Product Change Notice (PCN)

PCN Number: **PCN-0450470R-01**

Product(s) Affected: **PJ-014D**

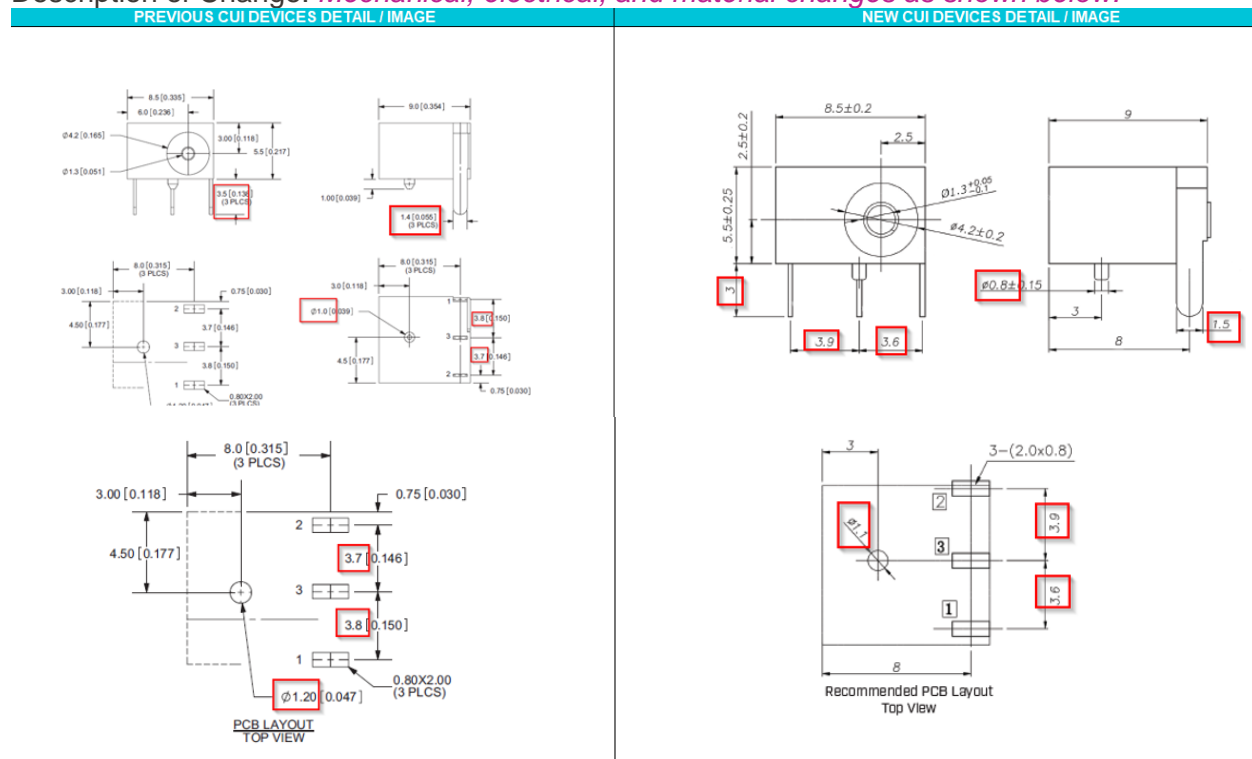
Description of Change: **Mechanical, electrical, and material changes as shown below:**

MATERIAL	PLATING
center pin	copper	nickel
terminal 1	brass	tin
terminal 2	copper alloy	tin
terminal 3	brass	tin
plastic	PBT

DESCRIPTION	MATERIAL	PLATING/COLOR
center pin	brass	silver
terminal 1	brass t=0.30	silver
terminal 2	stainless steel t=0.25	silver
terminal 3	brass t=0.30	silver
housing	PA66 (UL94V-0)	black
